RBG-47573

Subject: Response to Request for Additional Information on River Bend Station Recommendation
2.1 Flood Hazard Re-evaluation
River Bend Station - Unit 1
Docket No. 50-458
License No. NPF-47

**Attachment to
RBG-47573**

Response to Request for Additional Information

Figure F-1: Drainage Divide 1 - West Plant Road

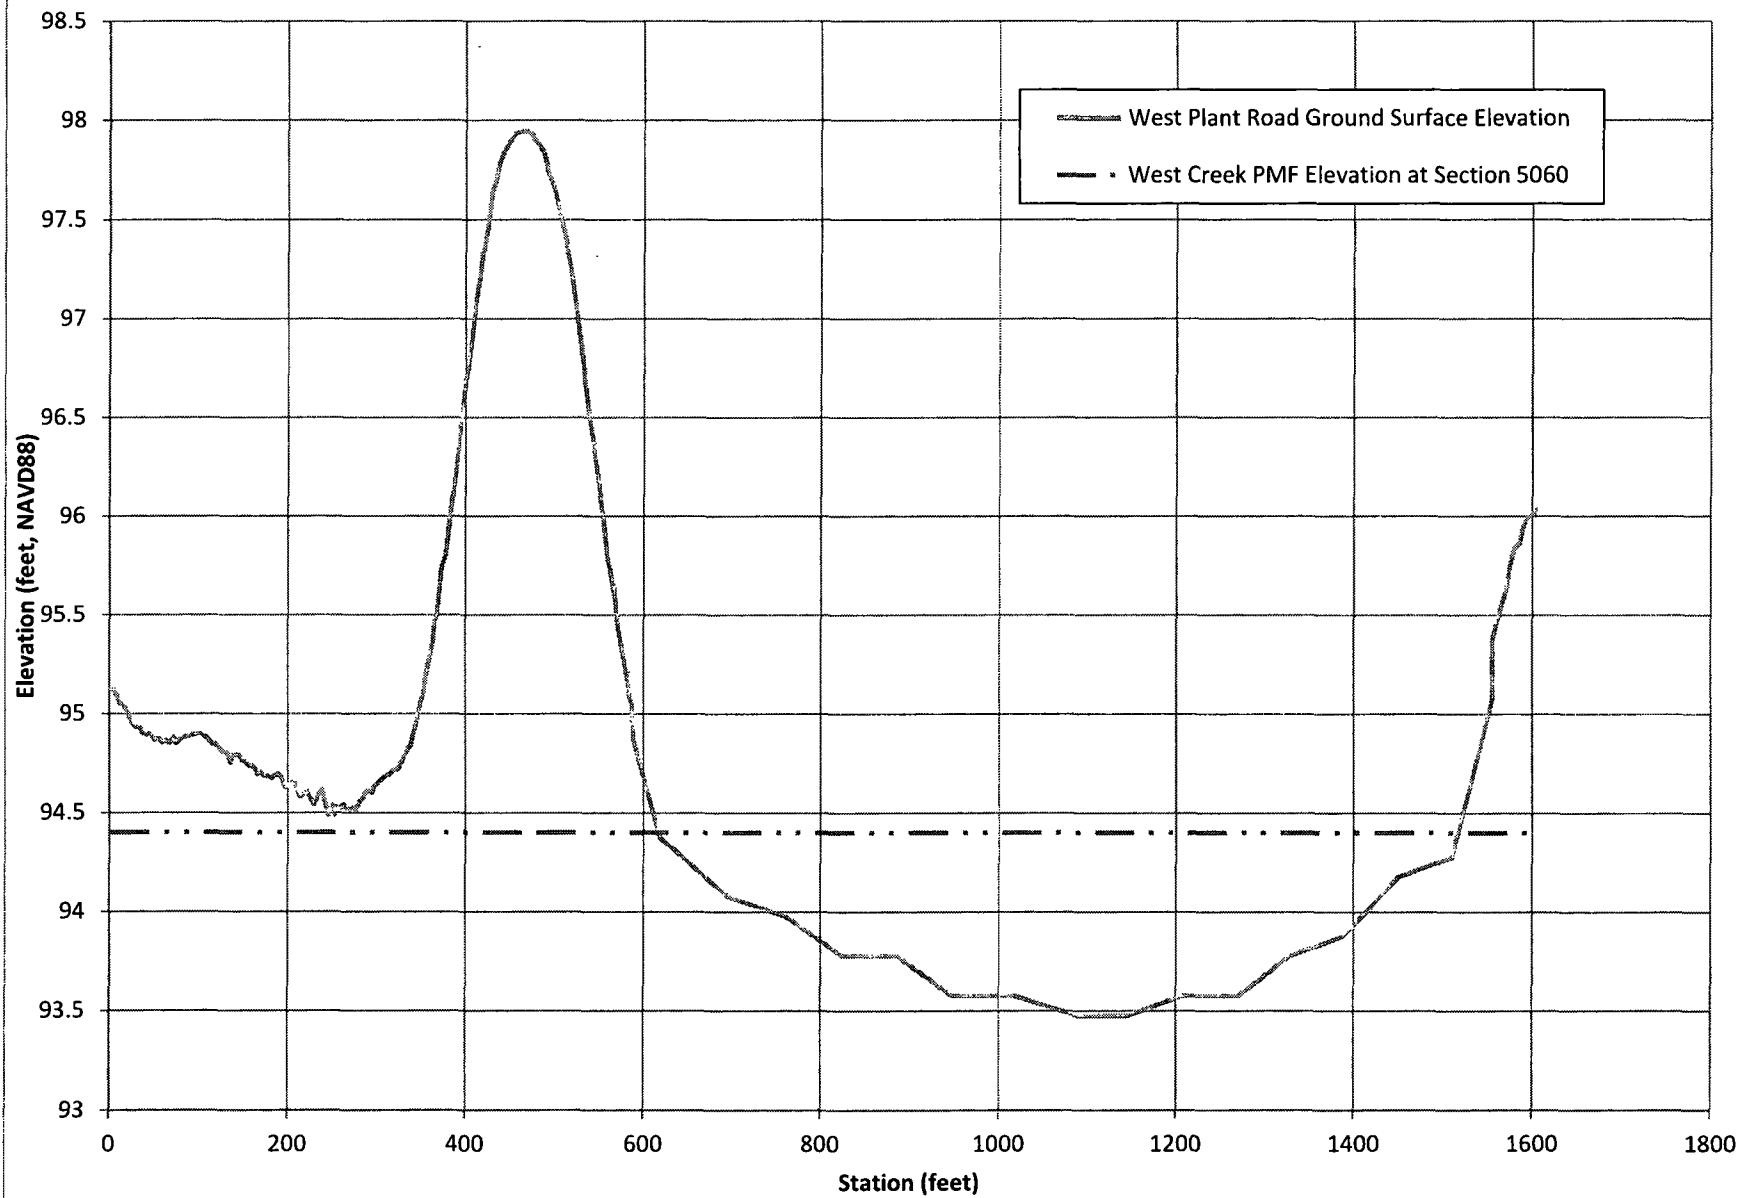
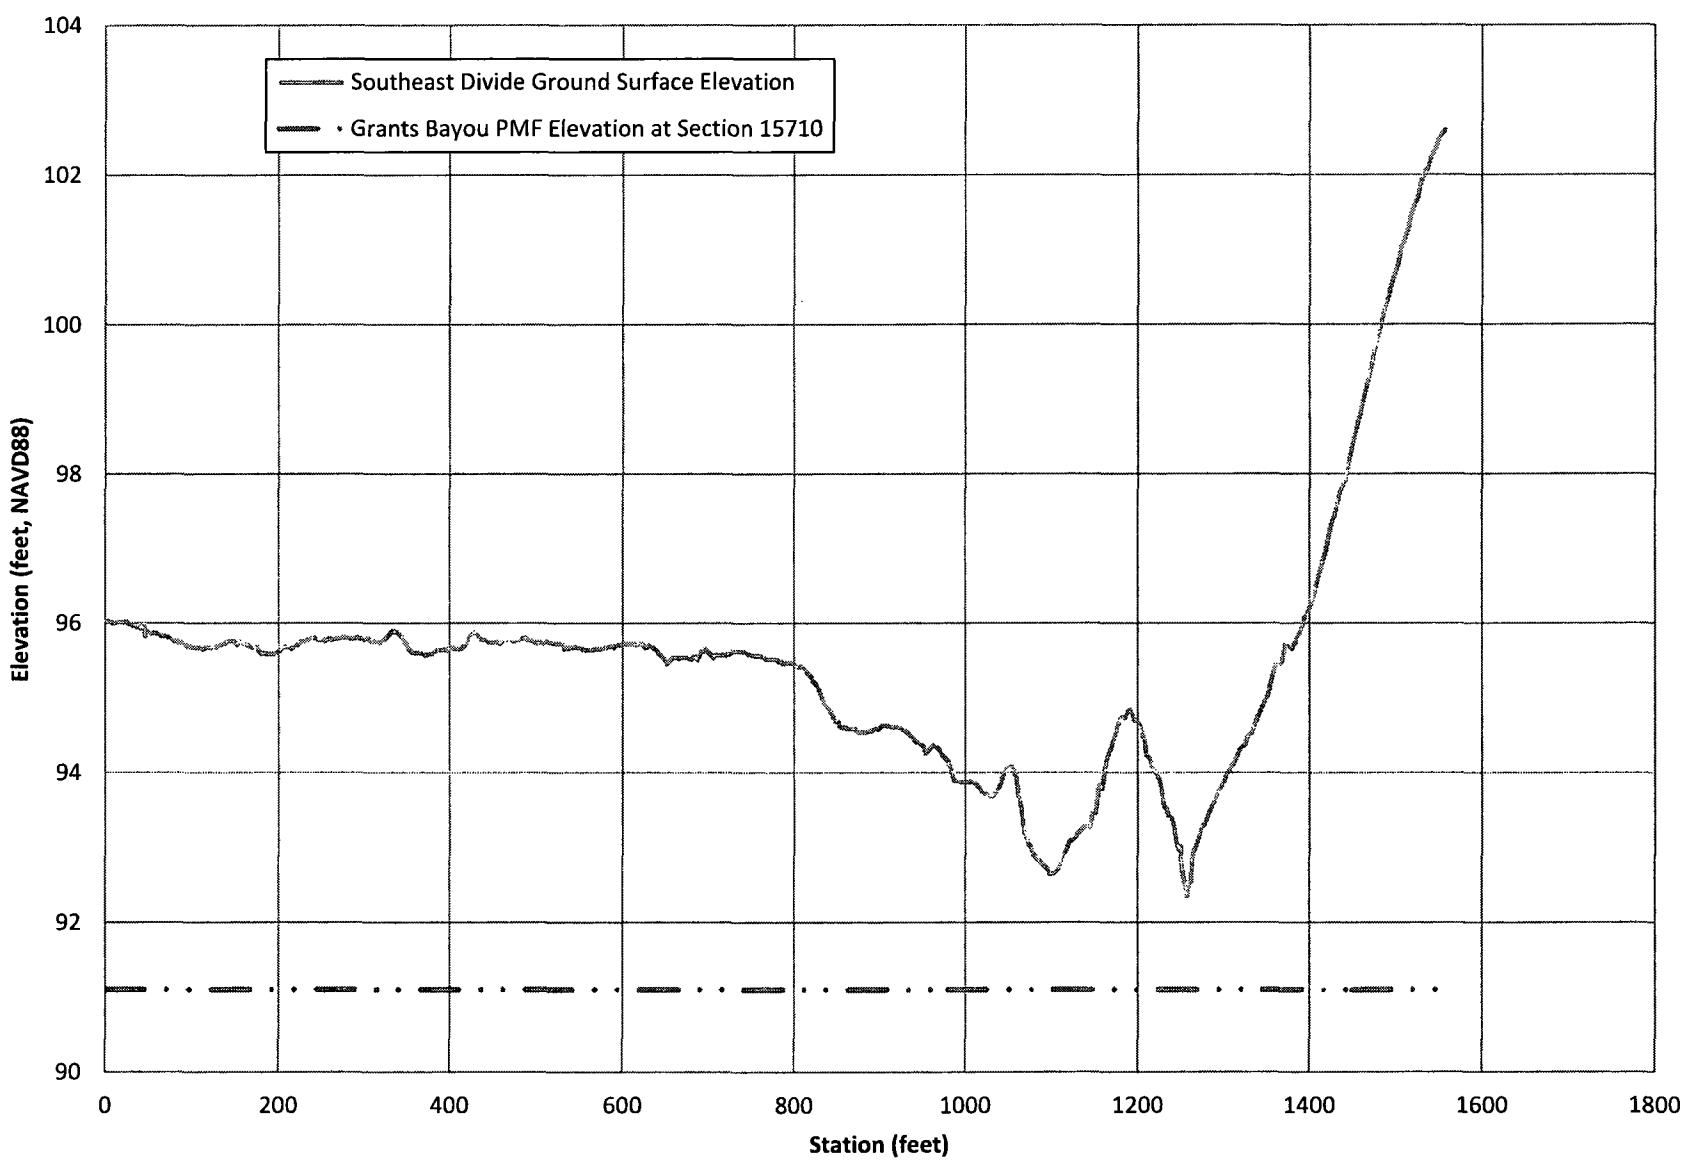
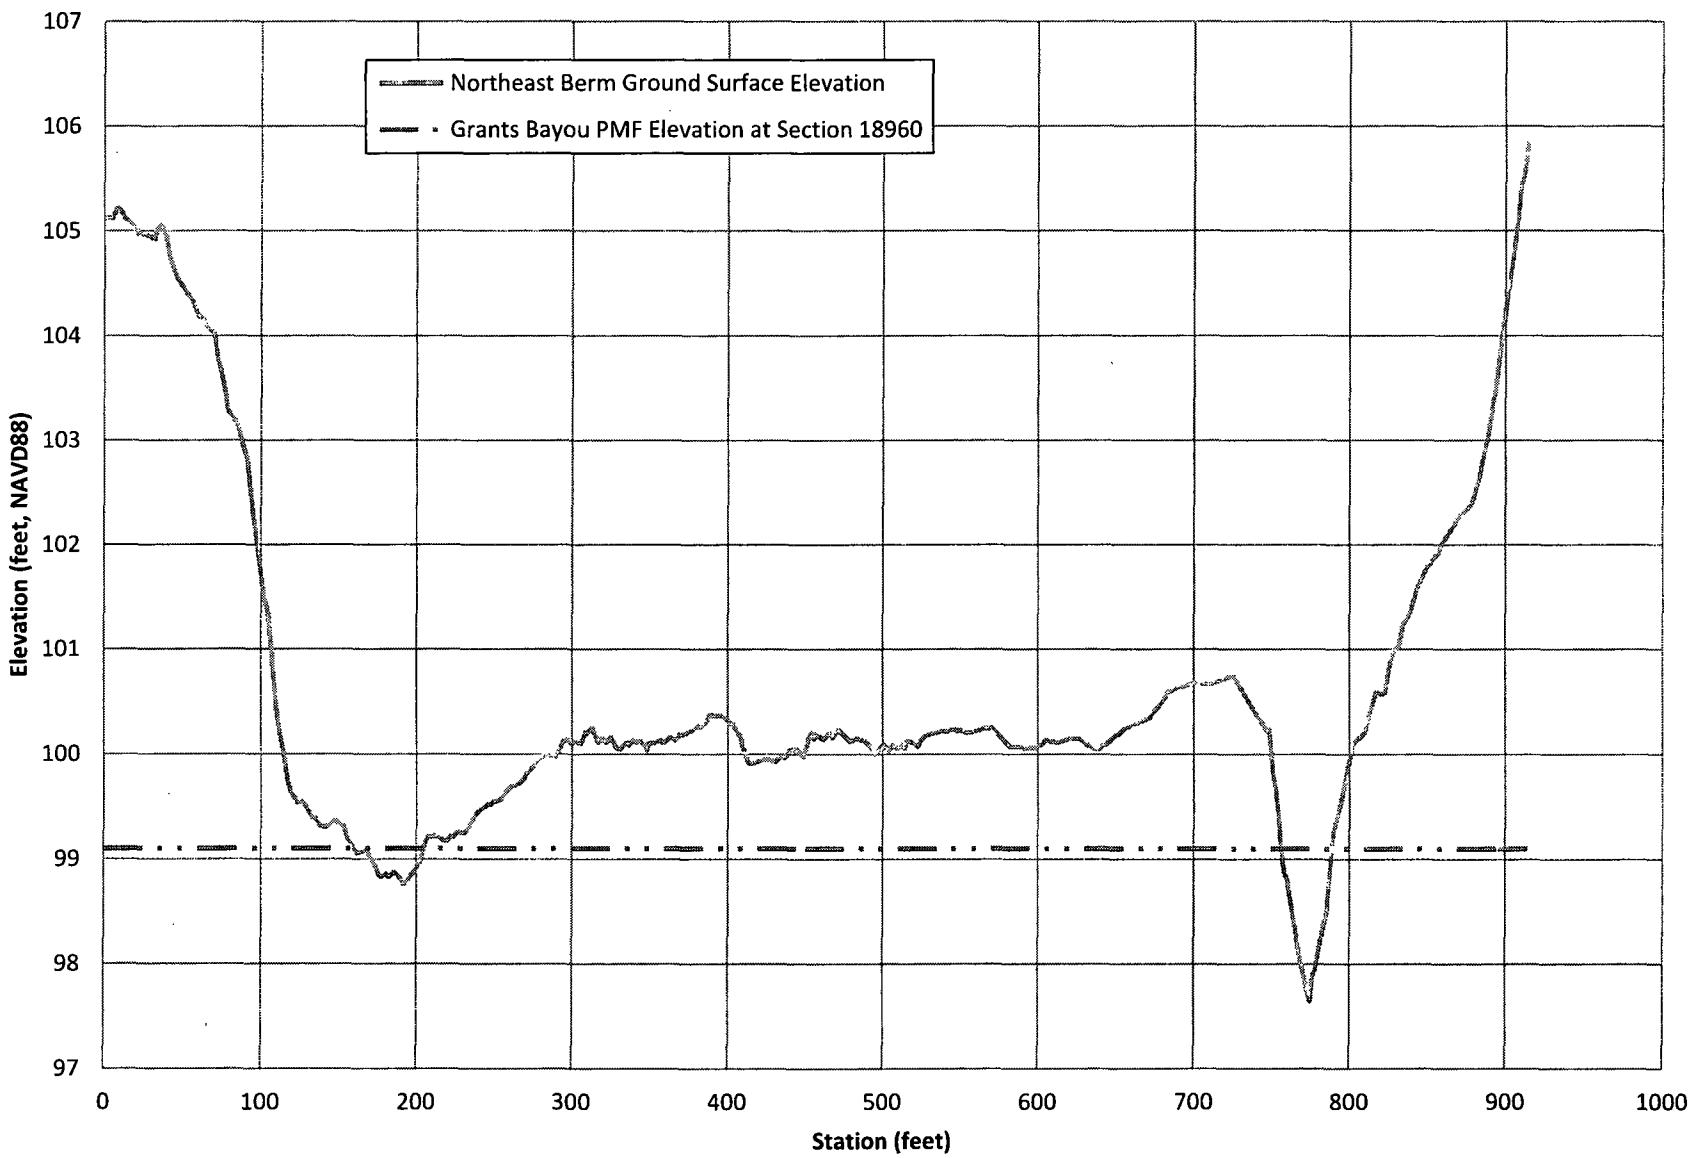
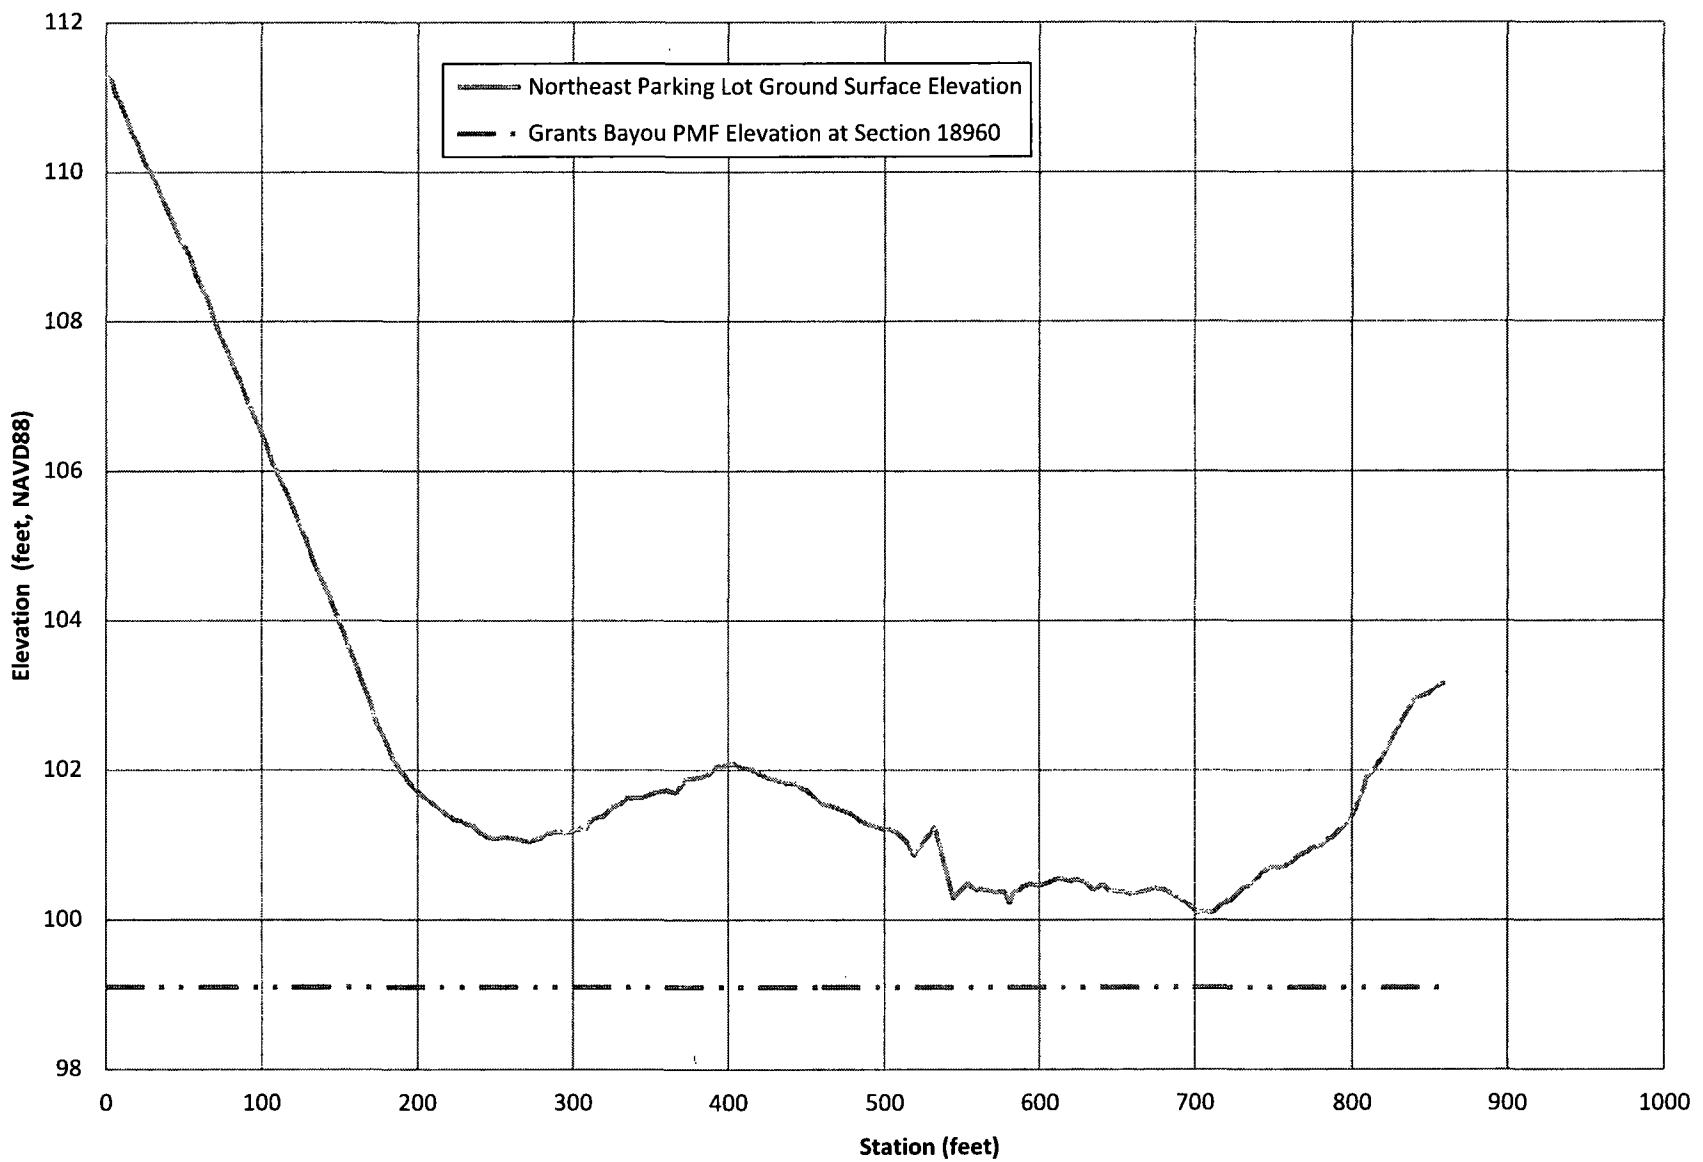
Request: *Provide delineation of site drainage divides, with pertinent elevation information, important to the reevaluation; and, where appropriate, whether each drainage divide provides a protected level in the design basis. Provide a figure to include visual reference to drainage divides mentioned in the text; and, clarify in Table 4.1-1 whether the Grants Bayou PMF, with and without wind and wave effects, is separated from the site by a drainage divide with a stated elevation or range thereof. Provide a figure showing the WPR drainage divide low point. Provide clarity to staff whether the WPR low-point this is a single point or a length of the road.*

Ground surface elevation profiles along the site drainage divides have been included as Attachment F. Low points referenced in the FHRR are called out along these drainage divides. The lowest point of West Plant Road, which is noted as 93.5 ft NAVD88, is a single point along the divide. The ground surface profile varies along West Plant Road (Drainage Divide 1) as shown in Figure F-1. The West Creek PMF overtops the divide along a distance of approximately 900 feet (Figure F-1). A map showing the drainage divide between West Creek and the RBS site is provided as Figure 4.
